CHICAGO TRANSIT AUTHORITY  
Advertisement for Bids

NOTICE OF TIME EXTENSION AND ADDENDUM #1

Req No: C11RI101126074, Spec. No. CTA 0039-10  
Purple Line Viaduct Replacements: Greenleaf Street,  
Dempster Street and Grove Street and Retaining Wall  
Rehabilitation.

**Contract No. C11RI101126074:****Purple Line Viaduct Replacements: Greenleaf Street, Dempster Street, Grove Street and Retaining Wall Rehabilitation Response to Bidders' Questions**

DRAWING NO. TS-501

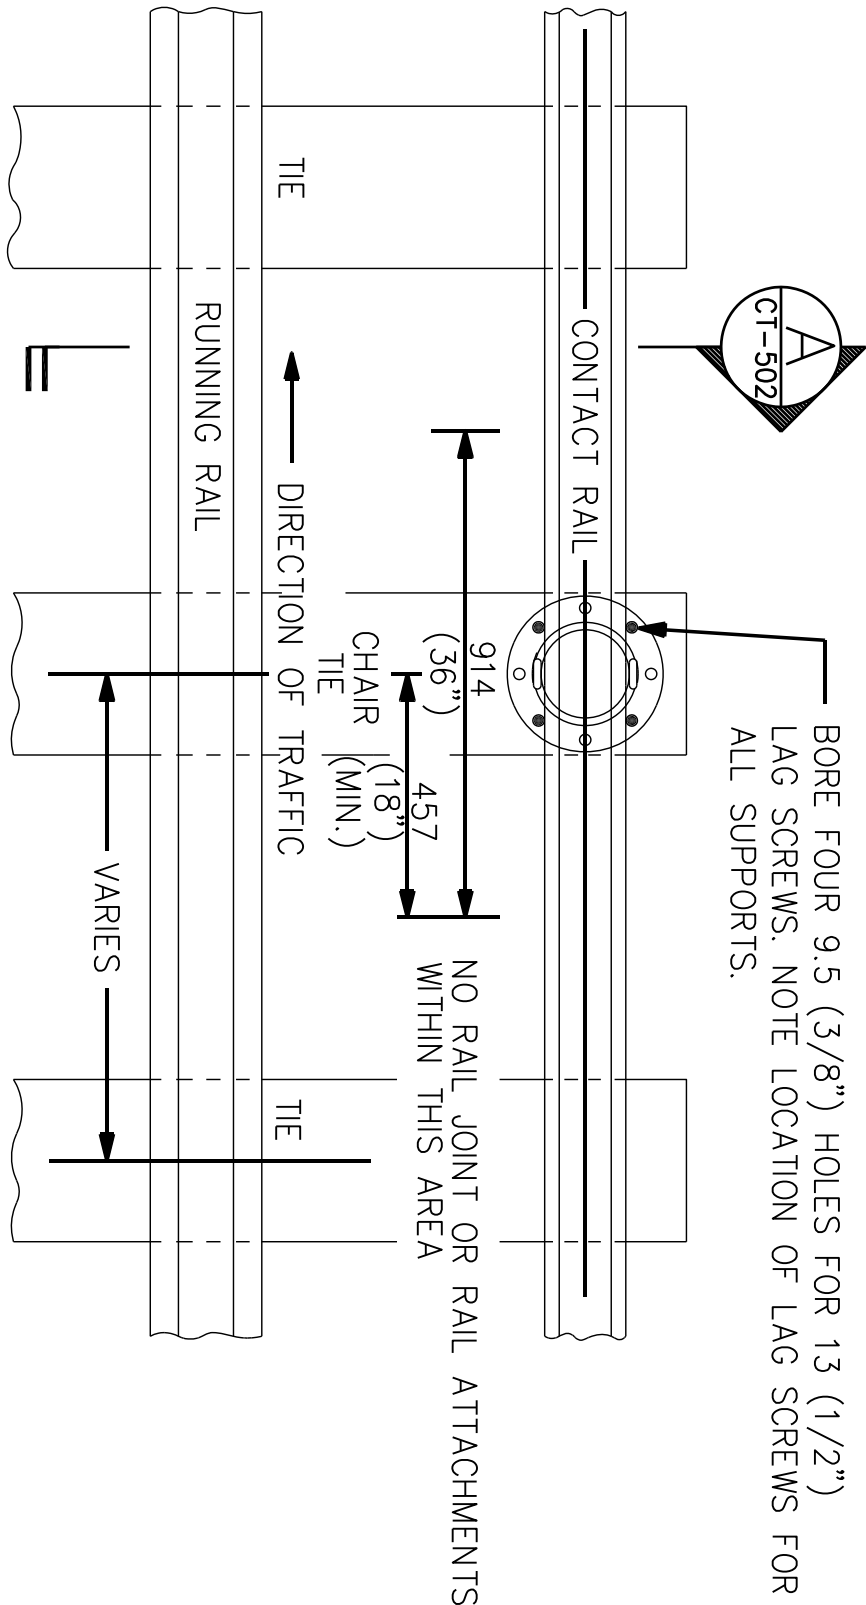
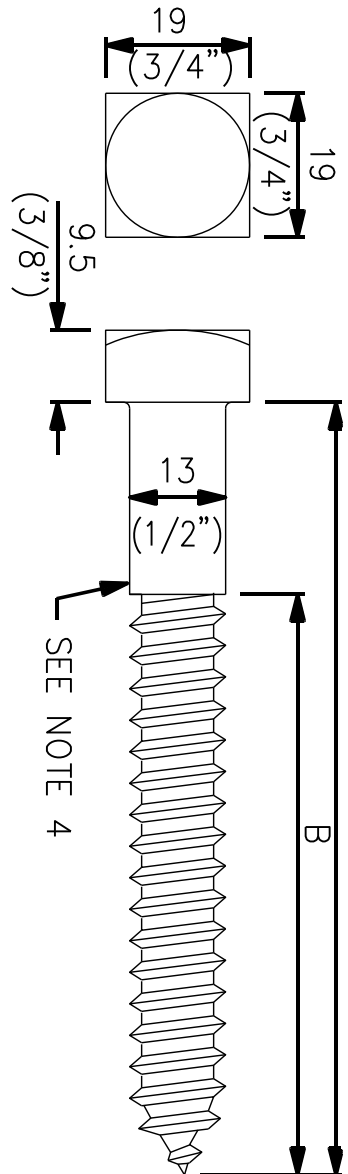
32				The track on the bridges are not to be machine tamped?	Correct, see Specification 2450, section 3.15A
33				During the weekend outage will the 3rd rail be shut off in between areas of work?	Power will be removed in the immediate area of the bridge being worked on. Additional power sections can be removed upon request and approval by CTA.
34				Type of test required for the field welds?	See drawing TS-500, note1

**DRAWING NO. SGRE-516**

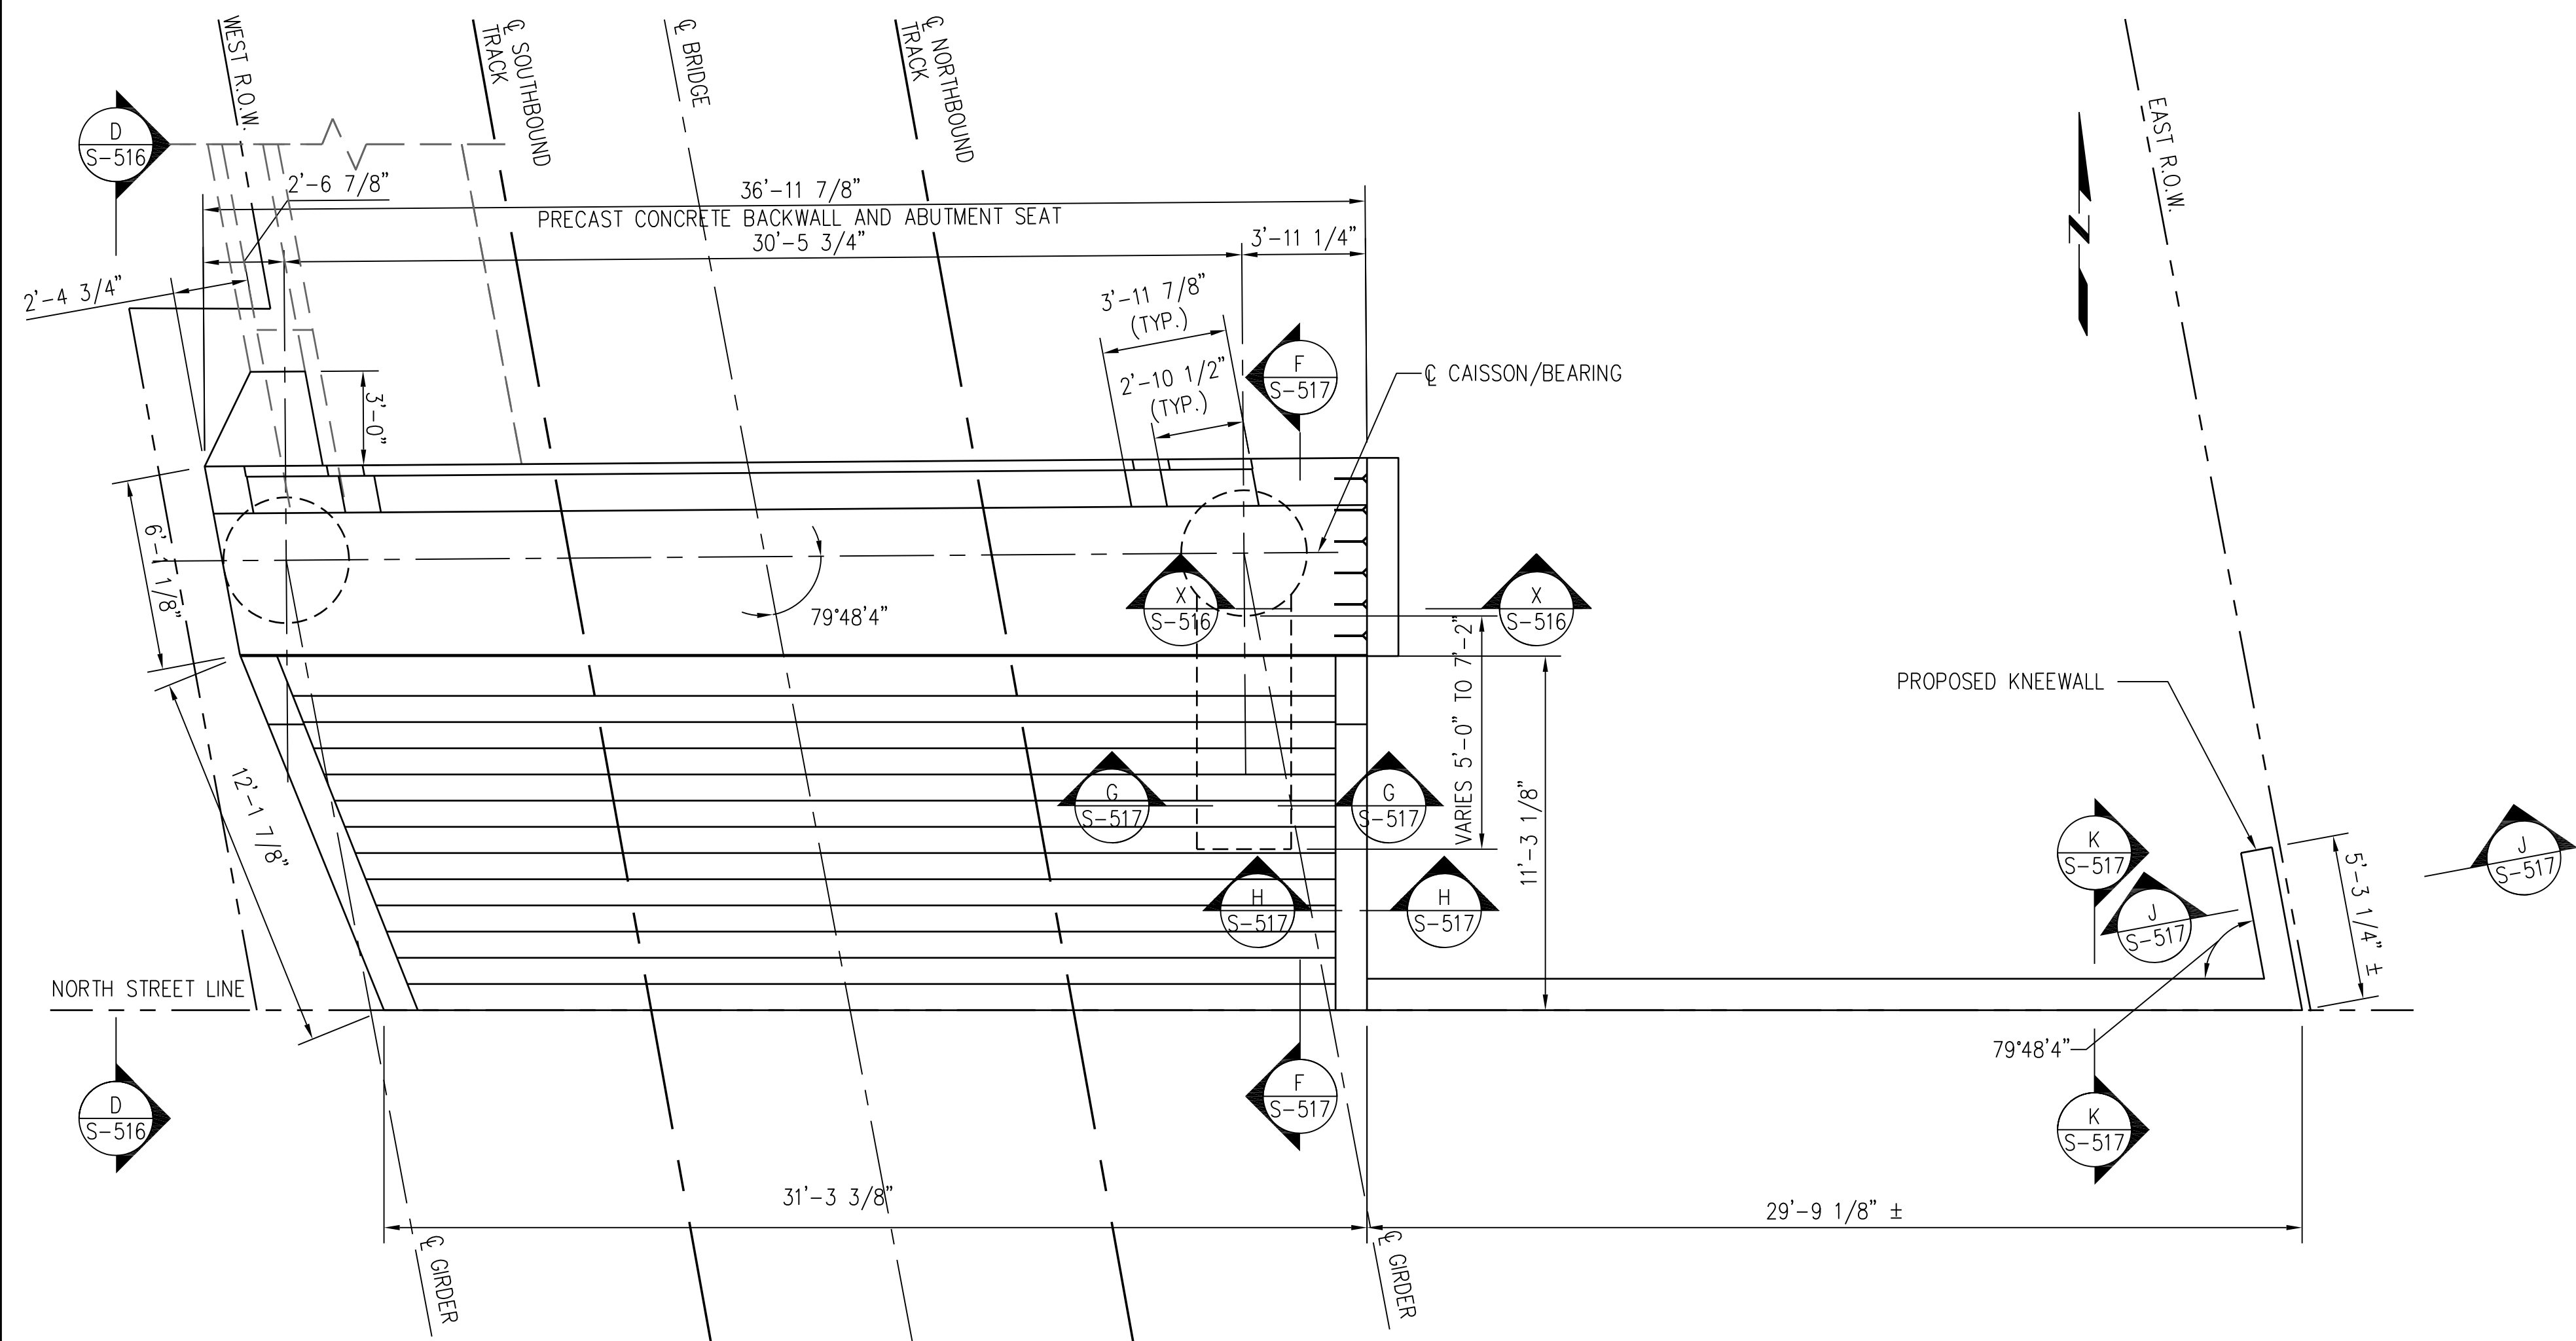
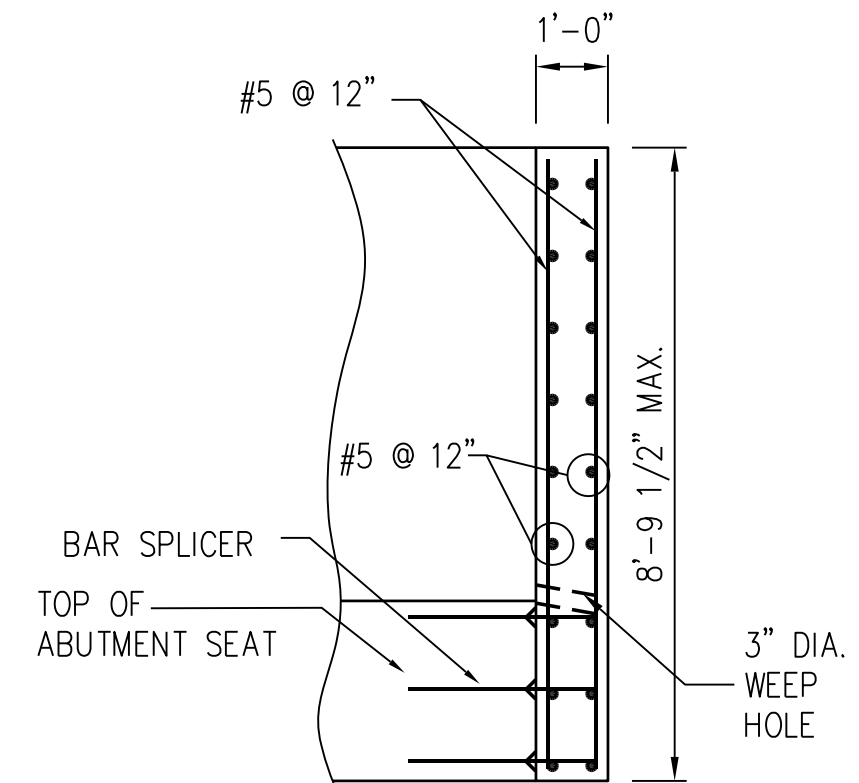
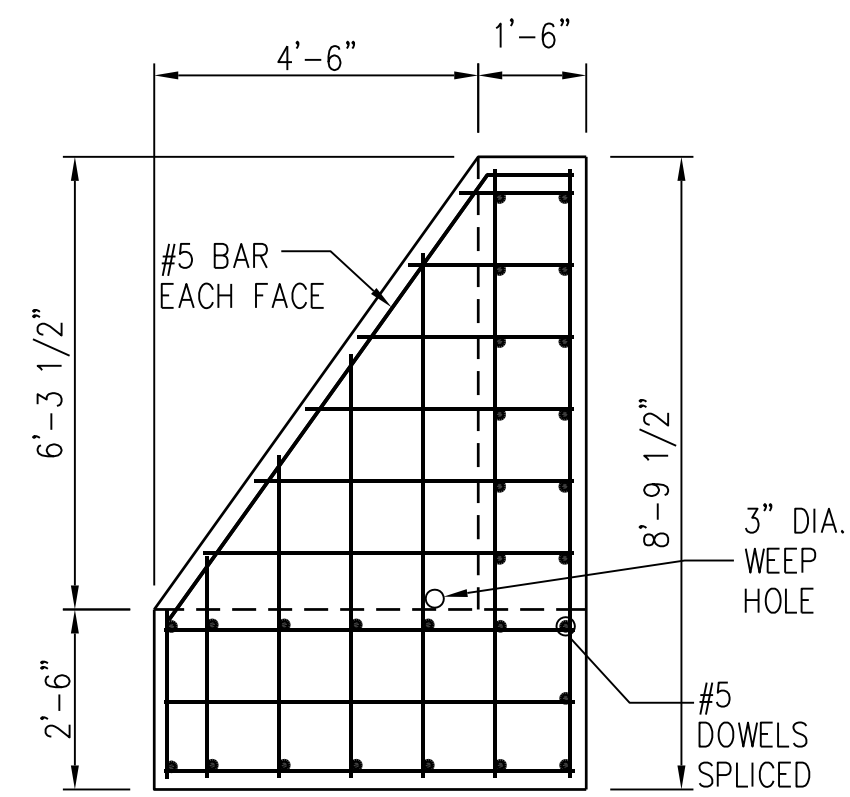
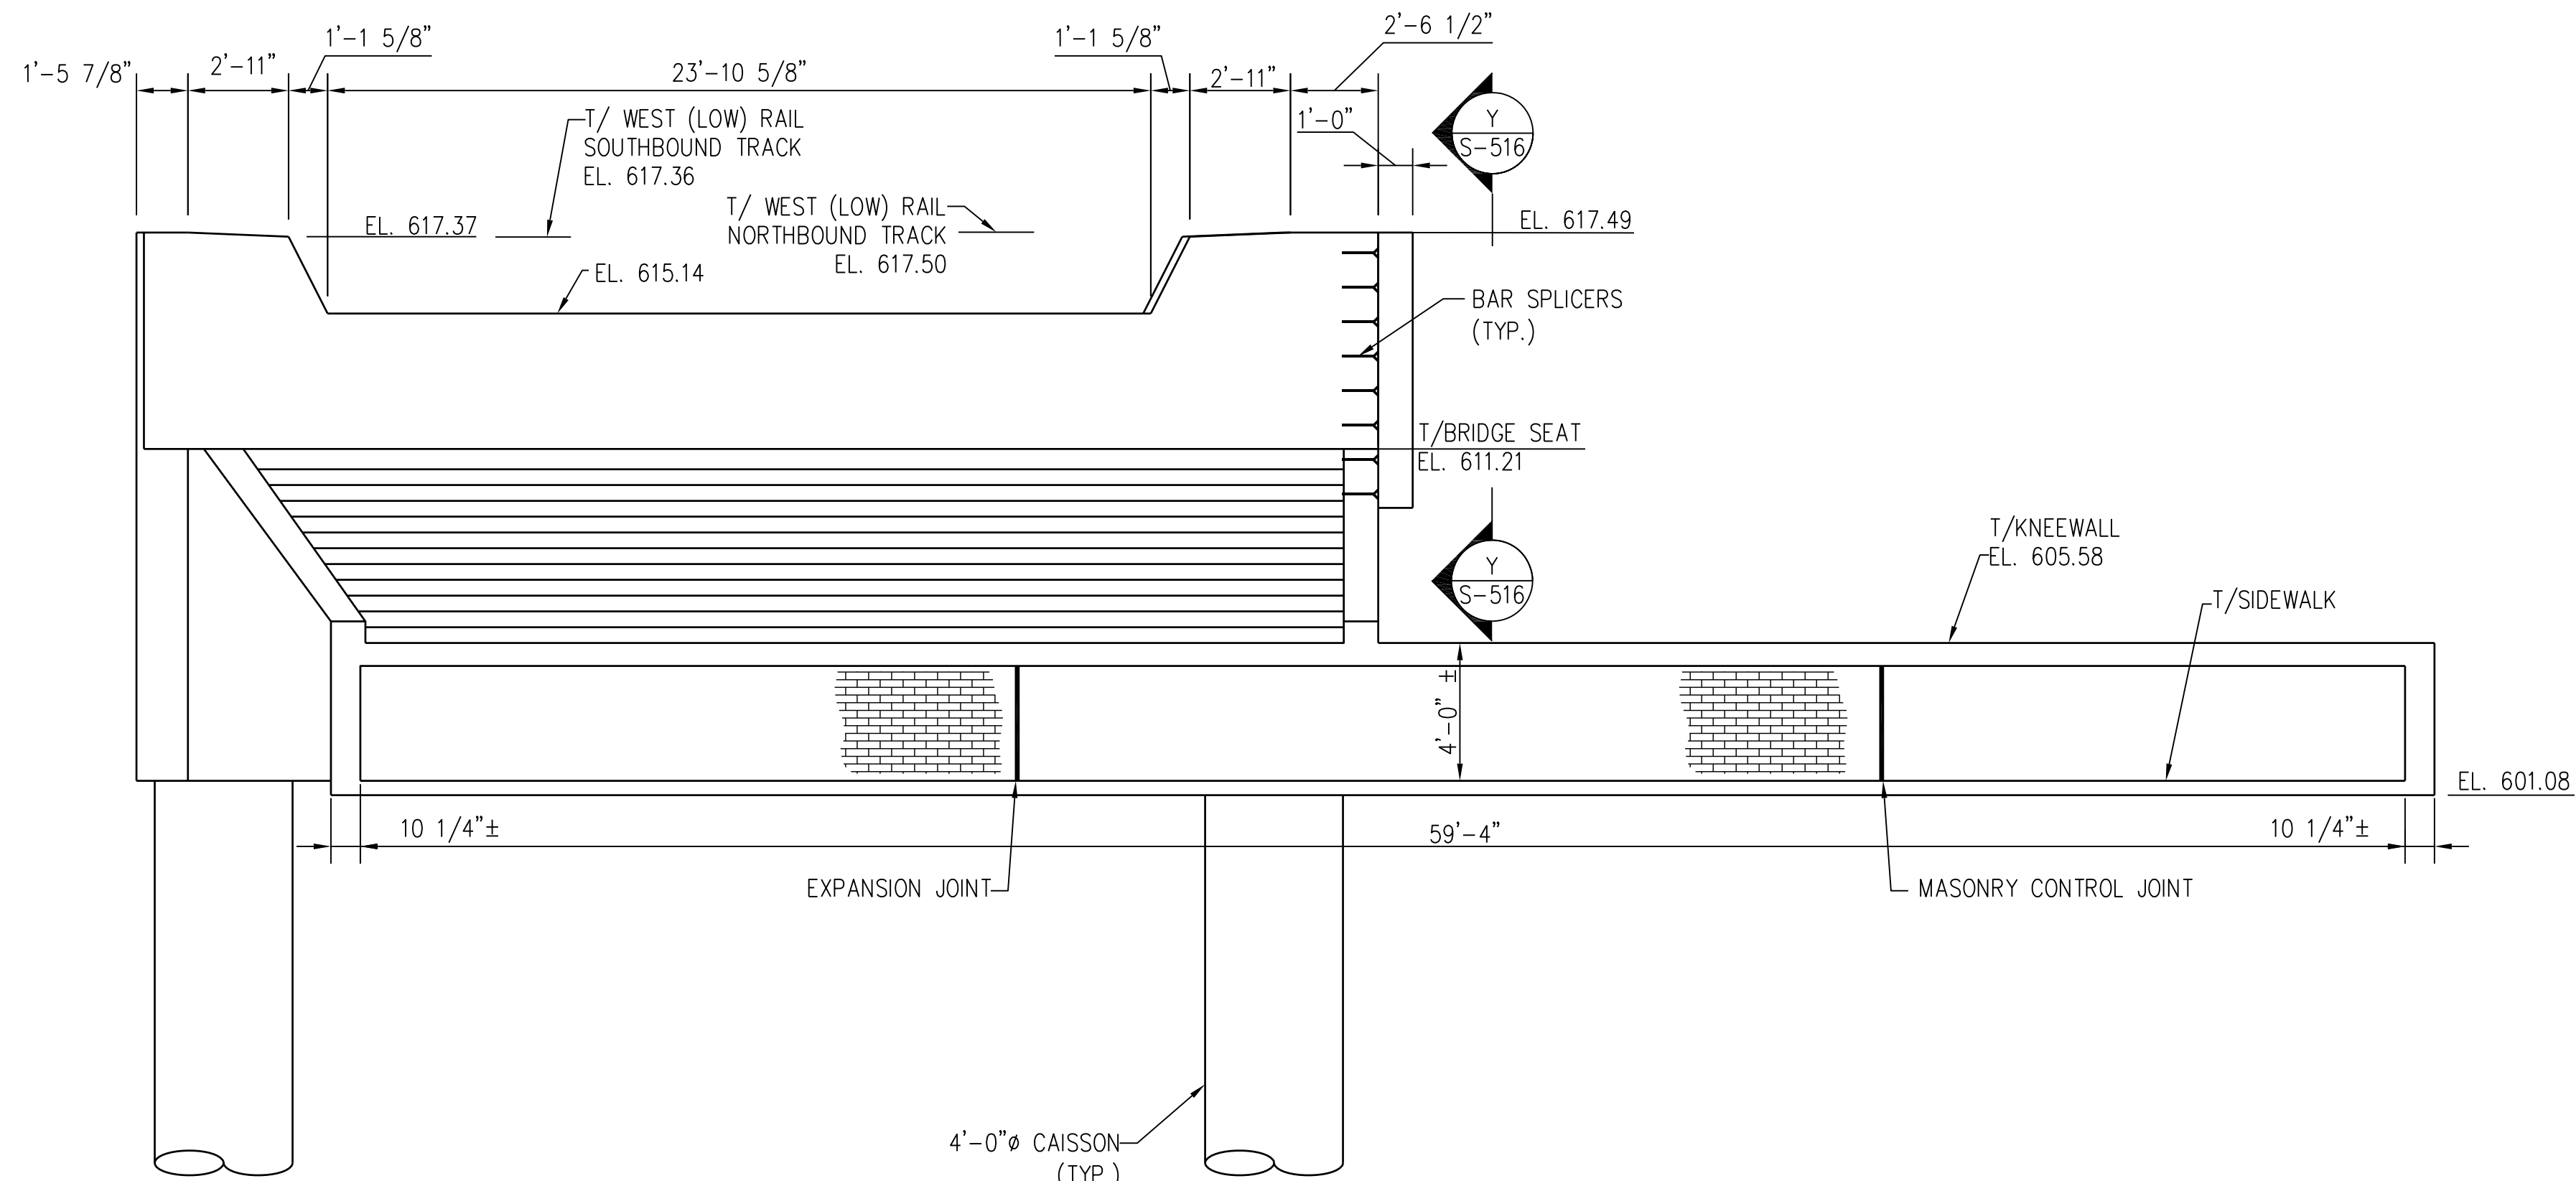
6		SGRE-516, SXGRE-003	Missing Drawings	Contract plan set is missing Sheet SGRE-516 "Proposed North Abutment". Sheet SDEM-516 has incorrectly been included in its place. Please provide this drawing sheet. Contract plan set is missing Sheet SXGRE-003 "Staging Location". Sheet SXGRO-003 has incorrectly been included in its place. Please provide this drawing sheet.	Addendum No. 1.
7	3200	WAL S-501 G-003	Galvanized Rebar	Rebars have (E) designation on S-501 while Note 3F on Sheet G-003 calls out galvanized rebar. The Spec. 3200 also calls out hot dip galvanized. Please clarify if rebar is to be epoxy coated or galvanized?	Rebar "(E)" designation has been removed. Per section 3200 all reinforcement shall be galvanized. See addendum No. 1.
8		WAL S-501		On drawing no. WAL S-501, Typical Wall Repair Details, It indicates that all the reinforcing steel used in the retaining wall repairs are Epoxy coated. Is this correct or should it be galvanized? And should the mesh be galvanized?	Per section 3200 all reinforcement shall be galvanized. See Addendum No. 1.
